AERONAUTICAL CHARTING MEETING
Charting Group
Meeting 21-02 – October 26 - 28, 2021

FAA Control #21-02-364

Subject: Airport Sketch – Final Approach Track

HELENA RGNL (HLN)
ILS or LOC Y RWY 27

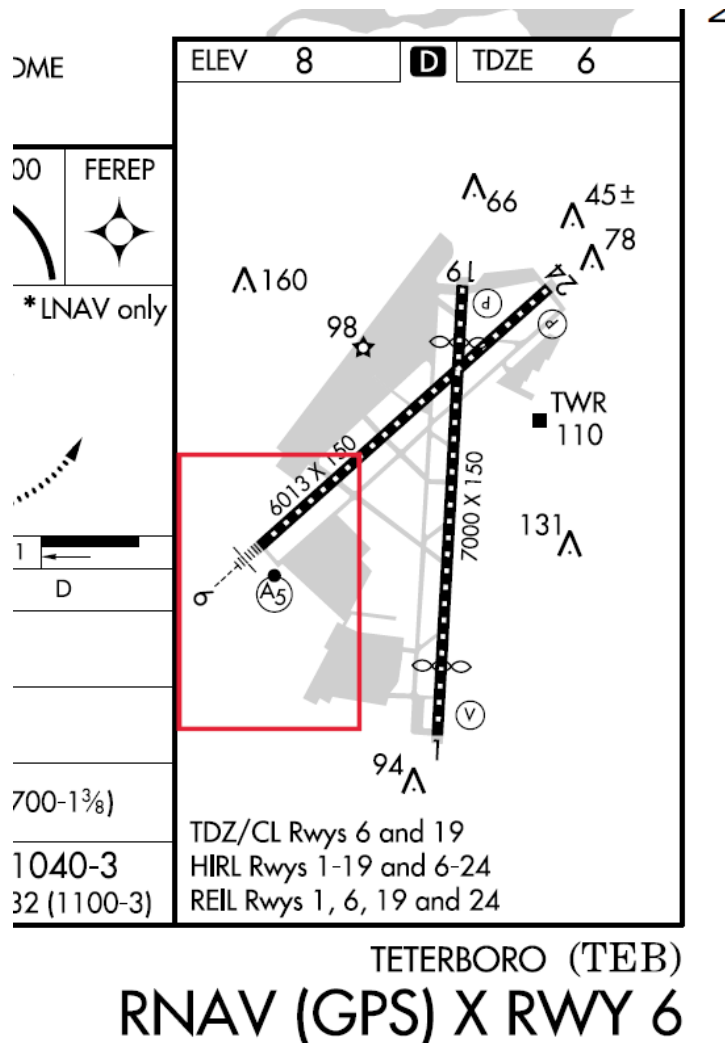
The Interagency Air Committee (IAC) Specification Document #4, paragraph 3.4.7.6 prescribes the criteria upon which the Final Approach Track is depicted on the instrument approach chart's Airport Sketch (exception: ILS CAT II, ILS CAT II & III, ILS SA CAT I, ILS SA CAT II, and ILS SA CAT I & II approaches). Here is an example for the ILS or LOC Y Rwy 27 approach at Helena, MT – KHLN:

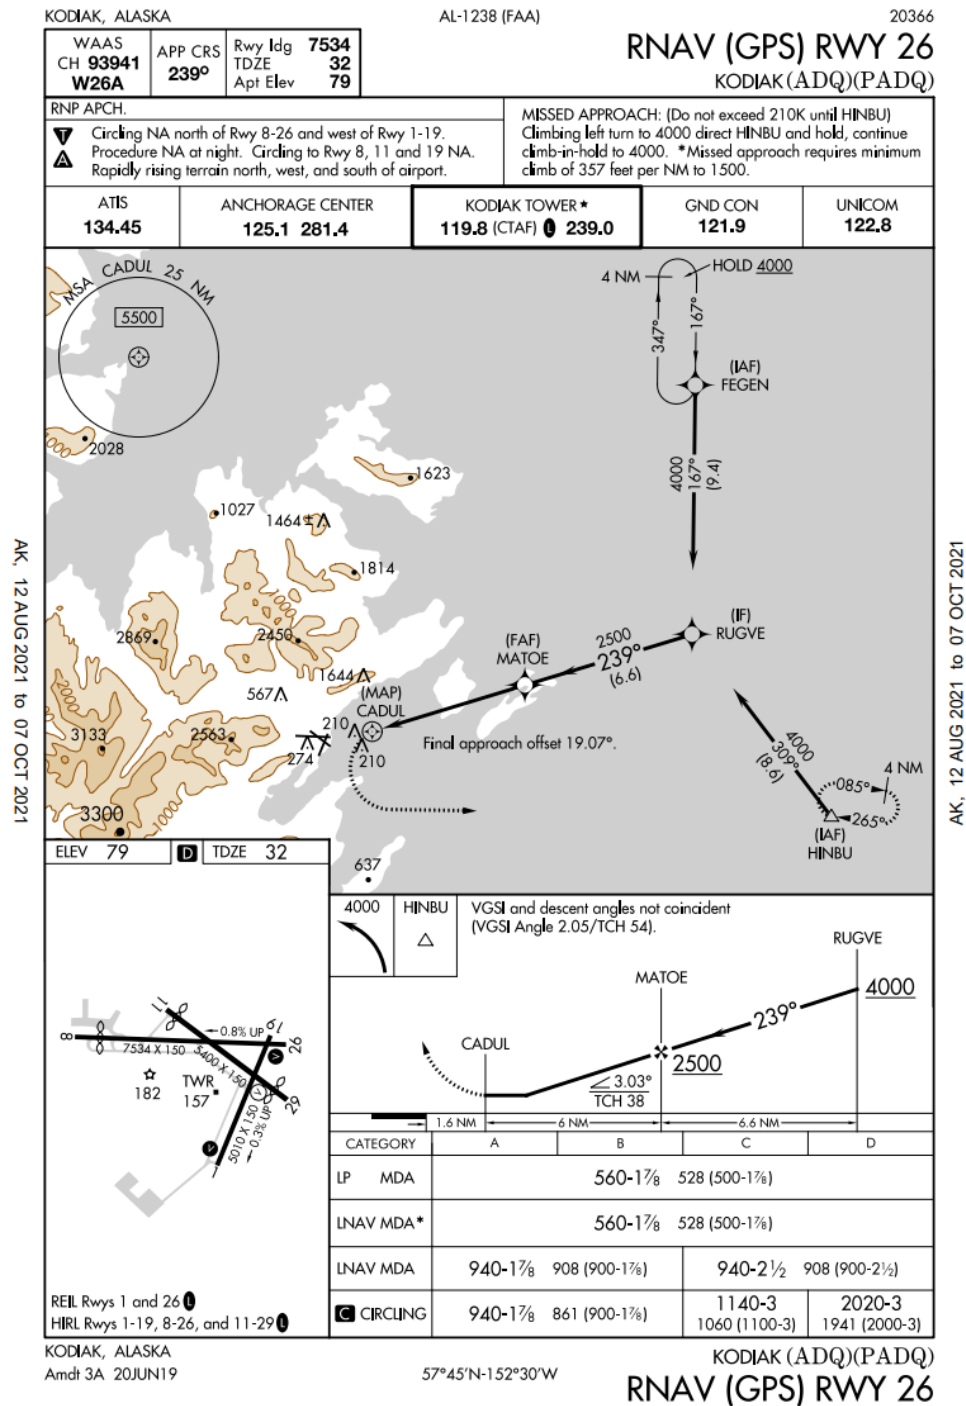
The Final Approach Track is shown only when the missed approach point (MAP) lies within the boundaries of the Airport Sketch. In a case where the MAP occurs prior to the Airport Sketch boundary, a Final Approach Track arrow will not be shown. Here is an example using the RNAV (GPS) X Rwy 6 at Teterboro, NJ – KTEB, where the MAP lies outside of the Airport Sketch boundary, and where the Final Approach Track is not depicted:

During the ACM-CG Instrument Approach Chart Modernization Working Group's activities, there was much discussion about whether this Final Approach Track should be depicted on the Airport Sketch in all cases (**except those ILS approaches noted above**) regardless of the location of the MAP in relation to the Airport Sketch boundary. Pilot participants generally agreed on the benefits of always charting the Final Approach Track, especially when the Final Approach Track was offset from the extended runway centerline. However, there was significant concern expressed by the charting community that depicting the Final Approach Track beyond the MAP on the Airport Sketch could be misinterpreted as implying that the approach is safe to continue beyond the MAP in IMC conditions, or that it could result in a delayed execution of the missed approach turn at the MAP.

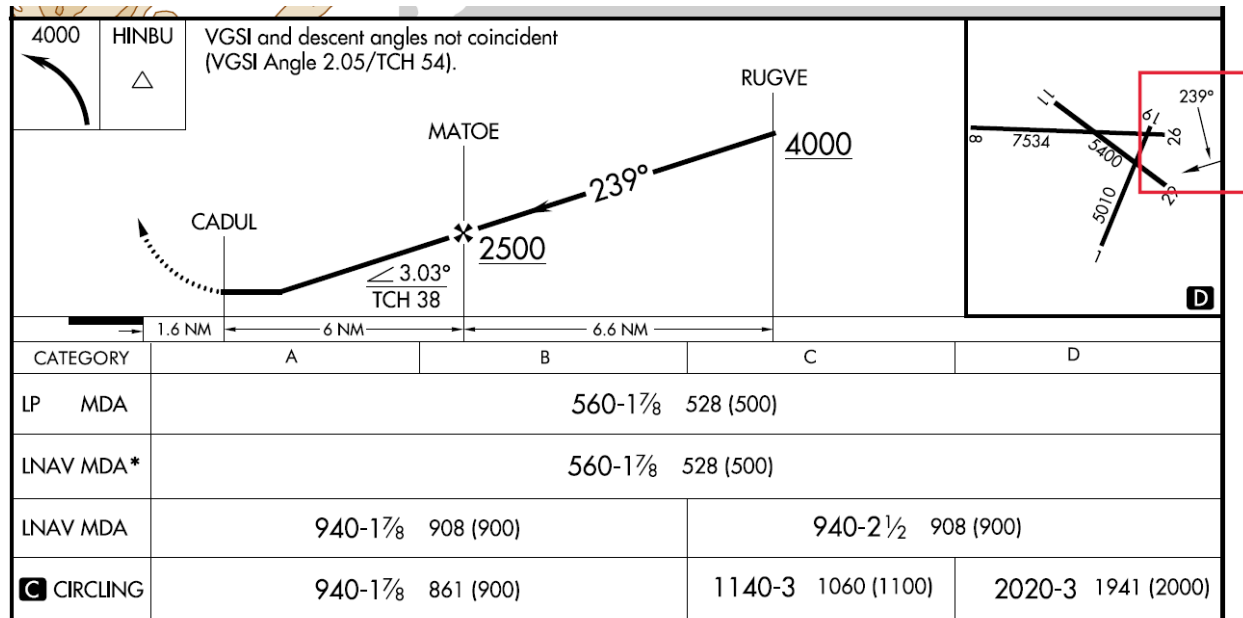
That later concern was illustrated when the working group looked at the RNAV (GPS) Rwy 26 at Kodiak AK – PADQ). In this procedure, the MAP (CADUL) is located 1.6 NM from the runway threshold. The final approach course is also offset from runway 26 by 19 degrees:

Because the MAP is located outside of the Airport Sketch, the Final Approach Track is not depicted. As part of its work, the ACM-CG working group prepared an option where the Final Approach Track was depicted on the revised Airport Sketch for comparison:

Again, there were differing opinions expressed on the depiction of the Final Approach Track when the MAP is located outside of the Airport Sketch. Pilots generally believed it beneficial to show the relationship of the final approach course to the landing runway as an aid to sighting aligning with the landing runway during the visual segment of the approach. Charting representatives expressed concern that doing so could imply to the pilot that it was safe to continue the approach beyond the MAP without the CFR-required visual references and that the course depicted by the arrow may be safely followed in such instances. There was also concern expressed that pilots might misinterpret the arrow as implying the missed approach procedure was a straight out missed instead of a turning missed, as described on the procedure.
